Model: **CR20**
CD changer mechanism

- Subject:** : Disc spacer is come off
Objective Model : CR20 (CD changer mechanism)
Symptom: : Disc spacer which is come off effect other mechanical operation.
 Therefore some symptom appear.
 * CD Changer operation does not work.
 * CD does not play.
 * CD tray does not open. and so on.

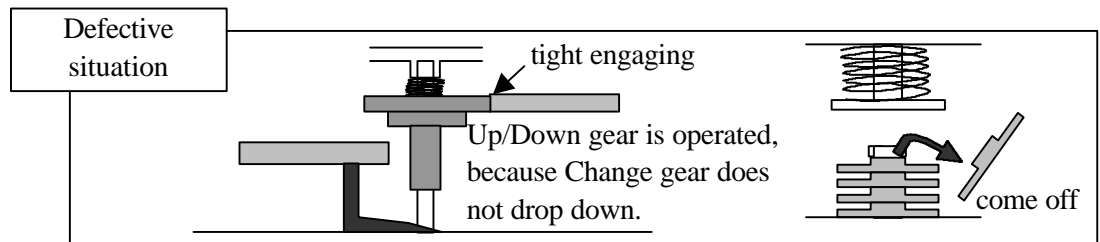
Cause: : This mechanism control the switching of Disc Up/Down and Tray Open/Close operation by Change gear. (Refer to following figures)

If the Change gear does not drop down due to tight engaging between Change gear and Drive gear when switching to tray open/close operation, Disc spacer come off.

Remedy: Replace the Change gear spring to strong one due the Change gear drop down surely.

Original	New
RMB0549	RMB0549-1
